## SERVICE INFORMATION NO. SI D4-178

EASA Airworthiness Directive No. 2014-0232  
TM TAE 125-0021, Revision 2 - Replacement Clutch  
ATA-Code: 72-10

Technische Mitteilung Nr. / Datum: TM TAE 125-0021, Rev. 2 / 13.10.2014  
Service Bulletin No. / Date TM TAE 125-0021, Rev. 2 / October 13, 2014

**Technische Mitteilung  
Nr. / Datum:** TM TAE 125-1011 P1, Rev. 2 / 31.08.2011

Fig. 1 Shoulder on the rear gearbox cover

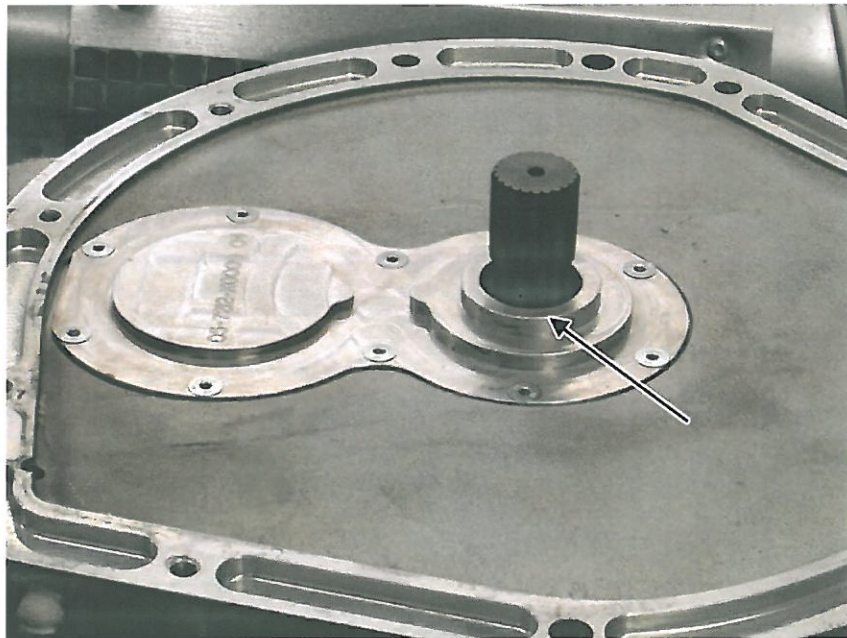
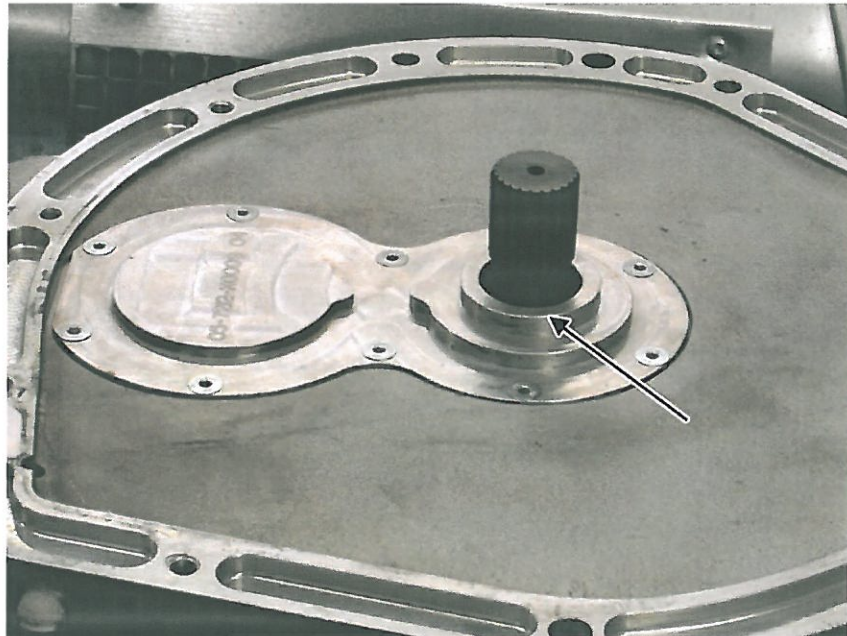
**If the rear gearbox cover has the part number 05-7212-K000904 and the shoulder shown in Fig. 1, you must rework the rear gearbox cover in accordance to work steps which follow. Otherwise, proceed to step 19.**

**Wenn der hintere Getriebedeckel die Teilenummer 05-7212-K000904 und den im Bild 1 sichtbaren Absatz aufweist muss der hintere Getriebedeckel nach den folgenden Schritten bearbeitet werden. Ansonsten mit Arbeitsschritt 19 fortfahren:**

Fig. 2 Install special tool

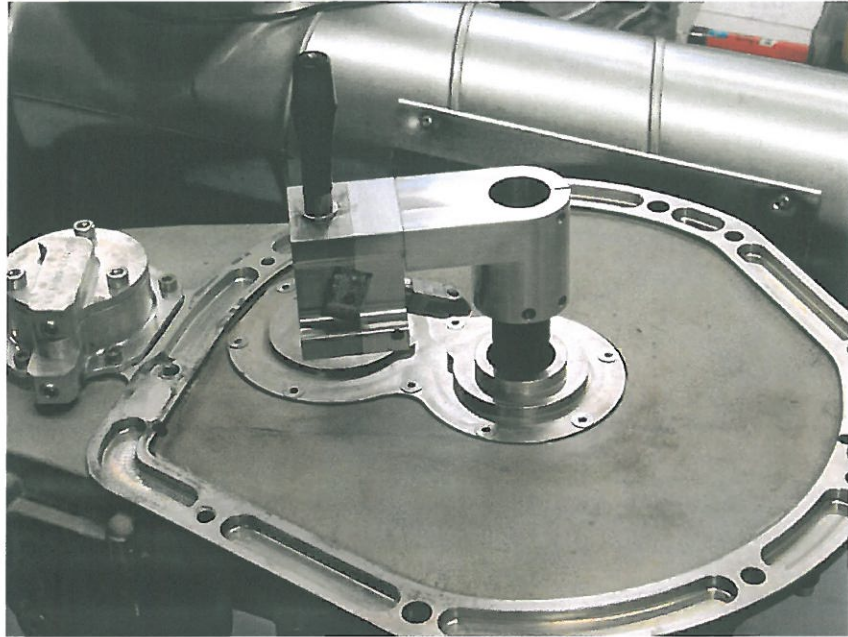
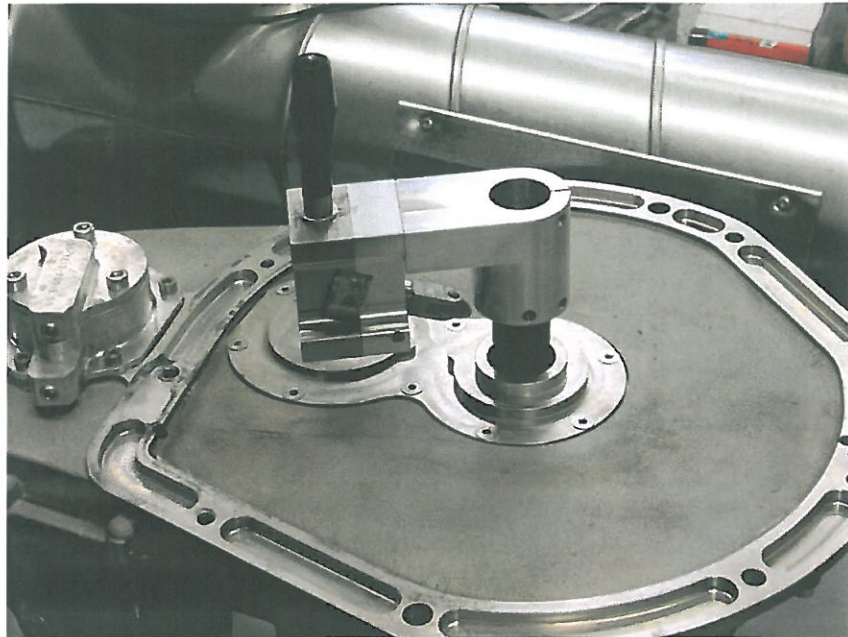
5. Put the special tool VR00388 to the input shaft of the gearbox. See Fig. 2.

5. Das Spezialwerkzeug VR00388 über die Getriebeeingangswelle führen. Siehe Bild 2.

Fig. 3 Adjust clearance with feeler gauge

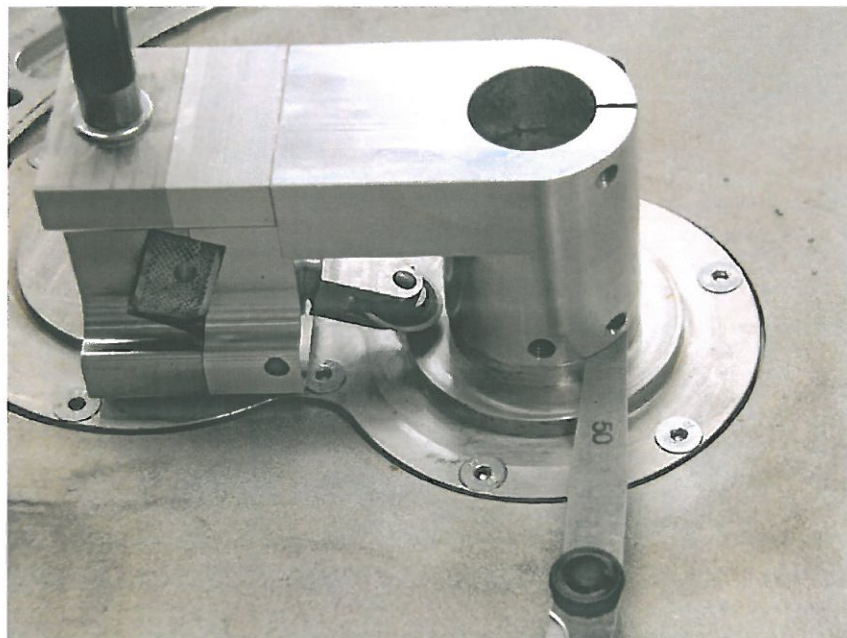
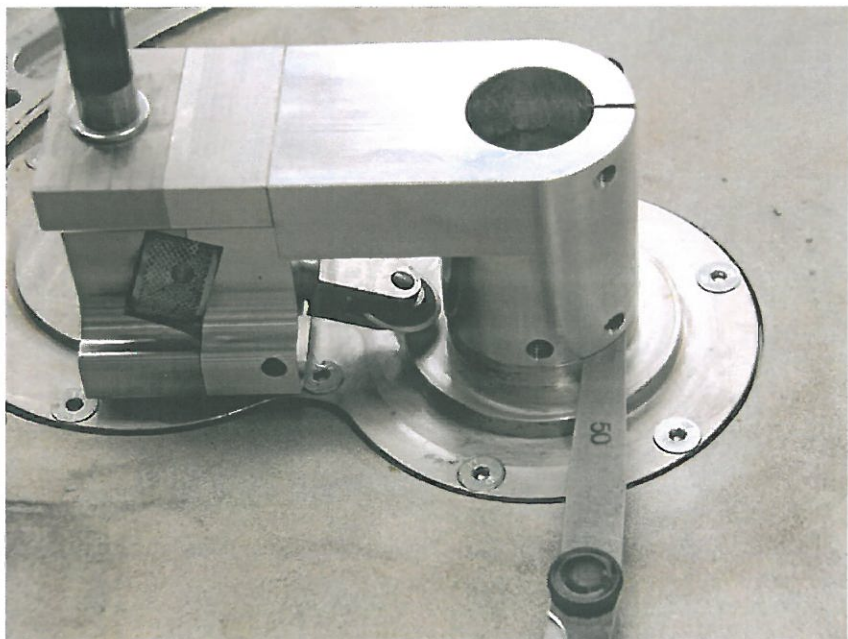
6. Move the special tool downwards to the rear gearbox cover until there is a clearance of 0.5mm between the special tool and the rear gearbox cover. Use a feeler gauge to ensure the clearance of 0.5mm. See Fig. 3.

6. Das Spezialwerkzeug aufschieben und mit einer Fühlerlehre einen Abstand von 0.5mm zwischen Spezialwerkzeug und dem hinteren Getriebedeckel einrichten. Siehe Bild 3.

Fig. 4 Screws for the attachment of the special tool

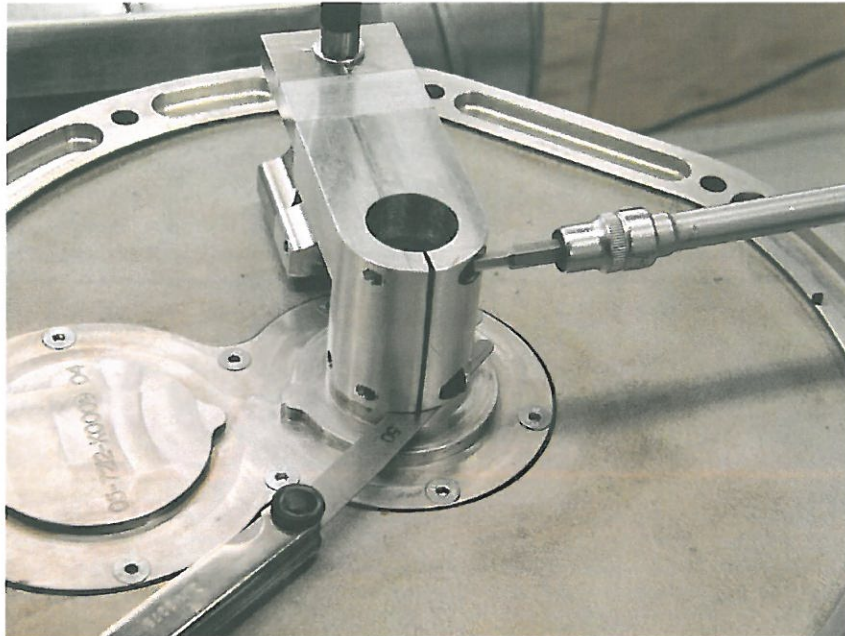
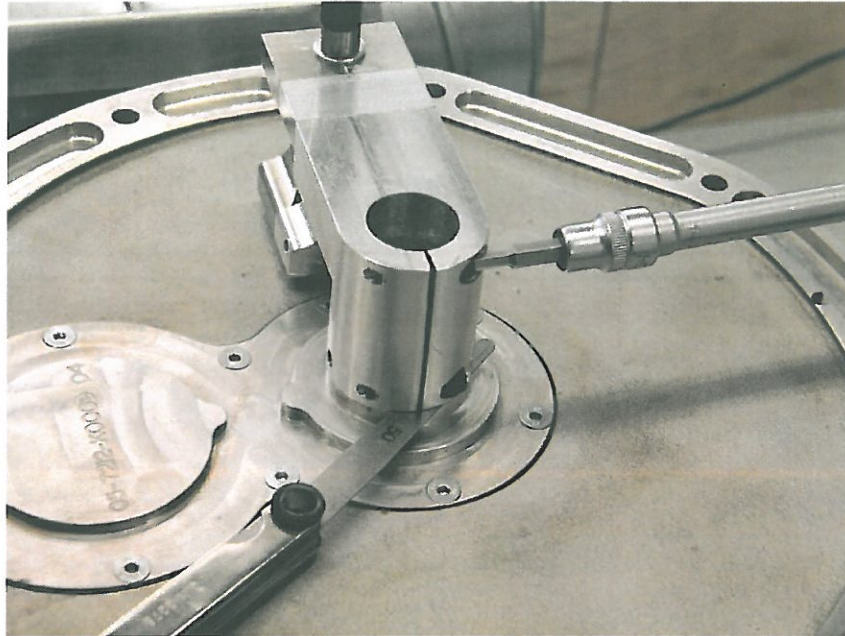
7. Tighten the two cylinder head screws to the specified tightening torque. See Fig. 4.

**Tightening Torque:**

7 Nm

7. Die zwei Innensechskantschrauben am Spezialwerkzeug mit dem vorgeschriebenen Drehmoment anziehen. Siehe Bild 4.

Fig. 5 Turn the adjustment wheel to feed the cutting tool

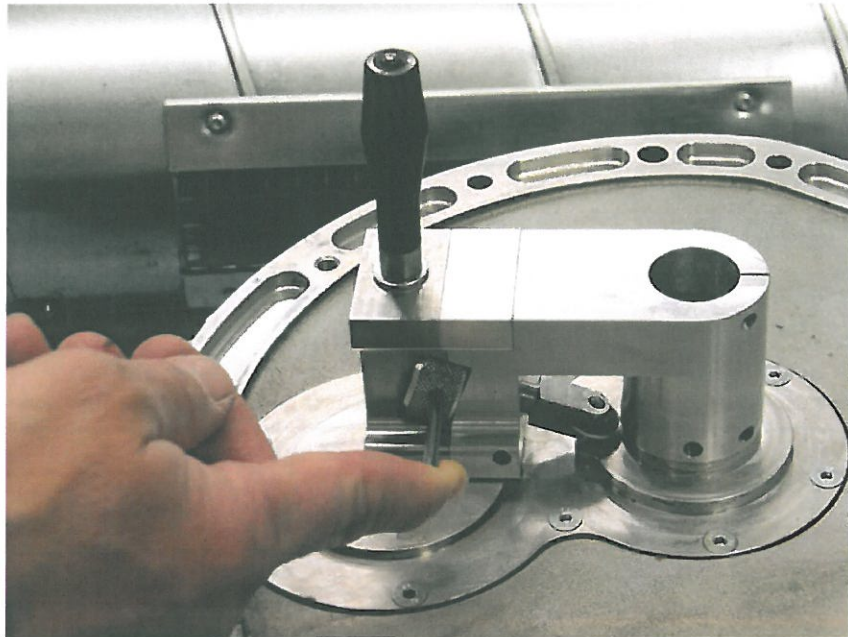
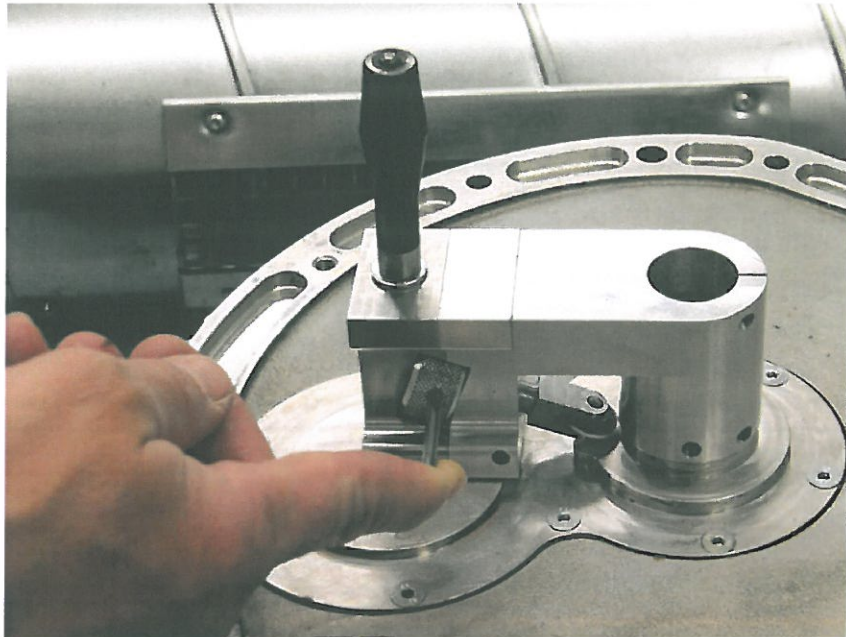
8. Remove the feeler gauge.  
9. Turn the adjustment wheel until the cutting tool touches the shoulder of the rear gearbox cover.  
10. Put the cylinder pin in the drill hole of the adjustment wheel. See Fig. 5.  
11. Turn the adjustment wheel until the cylinder pin touches the housing of the tool. See Fig. 5.

- **CAUTION:** Do not turn the adjustment wheel more than 45°. It can cause damage to the cutting tool!
- ◆ **Note:** Use the cylinder pin to turn the adjustment wheel. See Fig. 5.

8. Fühlerlehre entnehmen.
9. Das Einstellrad soweit drehen bis das Schneidwerkzeug am Bund des Getriebedeckels anliegt.
10. Den Zylinderstift in die Bohrung des Einstellrades stecken. Siehe Bild 5.
11. Das Einstellrad soweit drehen bis der Zylinderstift am Gehäuse des Werkzeuges anstößt.

- **ACHTUNG:** Das Einstellrad nicht weiter als 45° drehen, ansonsten kann das Schneidwerkzeug beschädigt werden!
- ◆ **Hinweis:** Den Zylinderstift zum Drehen des Einstellrades verwenden. Siehe Bild 5.

Fig. 7 Shoulder is cut through

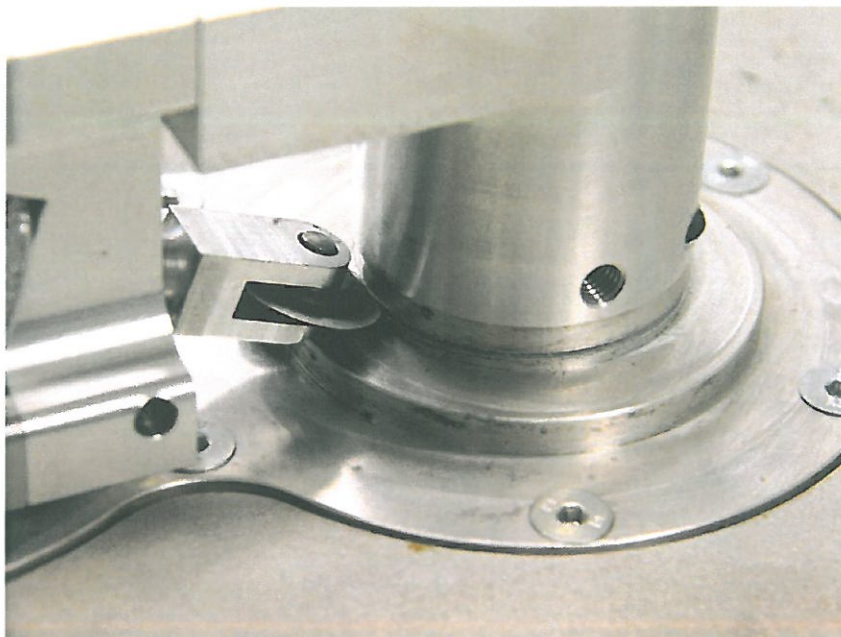
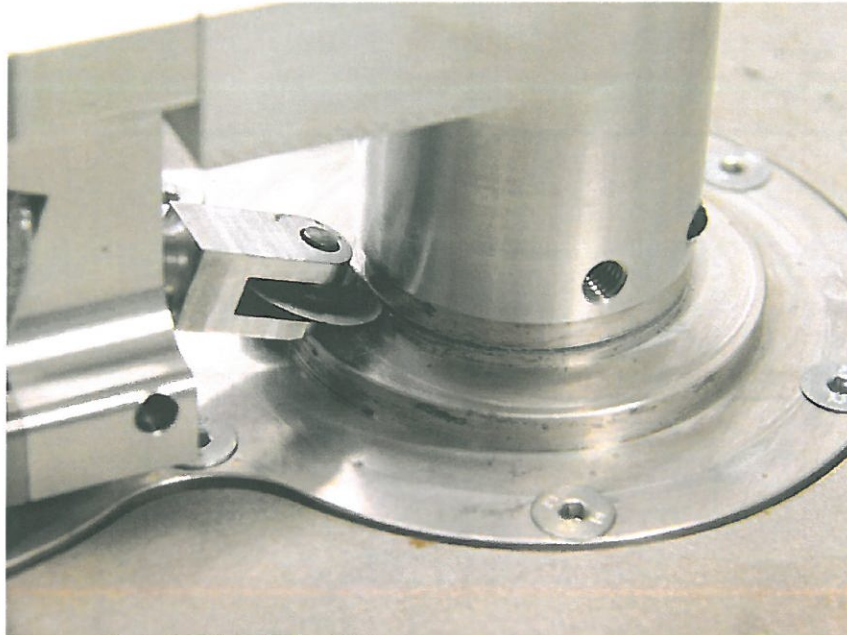
13. Feed the cutting tool. Refer to work step 12. Then turn the special tool. Refer to work step 13. Repeat work step 12 and 13 until the shoulder of the rear gearbox cover gets loose. See Fig. 7.

13. Anschließend analog zu Arbeitsschritt 12 das Schneidwerkzeug weiter zustellen und das Spezialwerkzeug am Griff drehen. Die Arbeitsschritte 12 und 13 solange wiederholen, bis sich der Bund vom Getriebedeckel löst. Siehe Bild 7.

Fig. 8 Remove the shoulder

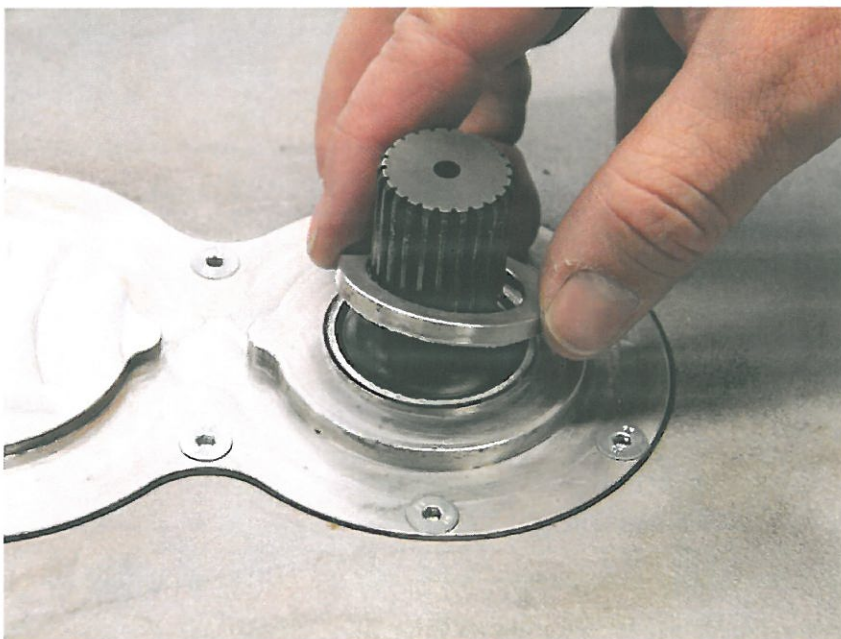
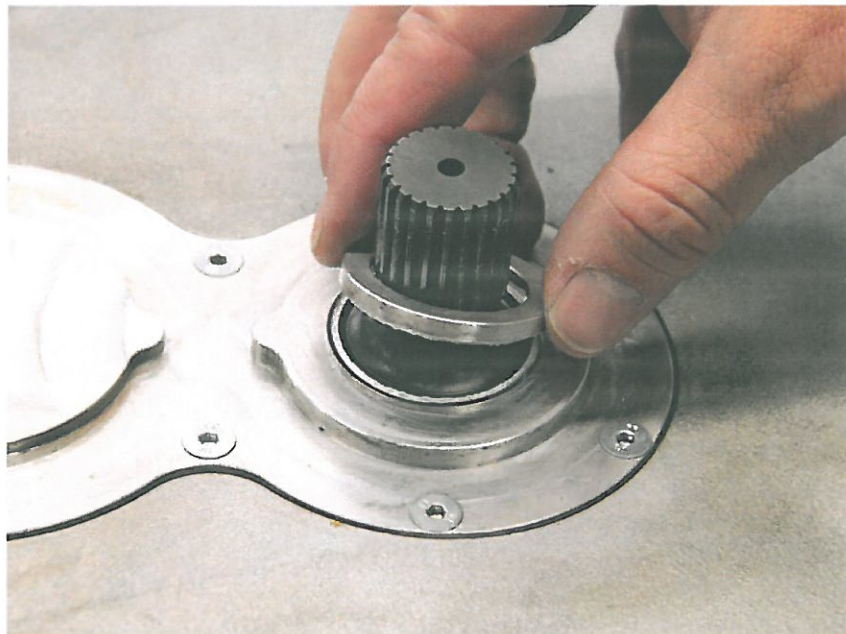
14. Turn the adjustment wheel backwards until the cutting tool has enough clearance to the shoulder to remove the special tool.
15. Loosen the cylinder head screws of the special tool.
16. Remove the special tool.
17. Remove the shoulder of the rear gearbox cover. See Fig. 8.

14. Das Einstellrad zurück drehen bis das Schneidwerkzeug ausreichend Freigang zur Entnahme des Spezialwerkzeuges hat.
15. Die zwei Zylinderschrauben vom Spezialwerkzeug lösen.
16. Das Spezialwerkzeug abnehmen.
17. Den Bund vom Getriebedeckel abnehmen. Siehe Bild 8.
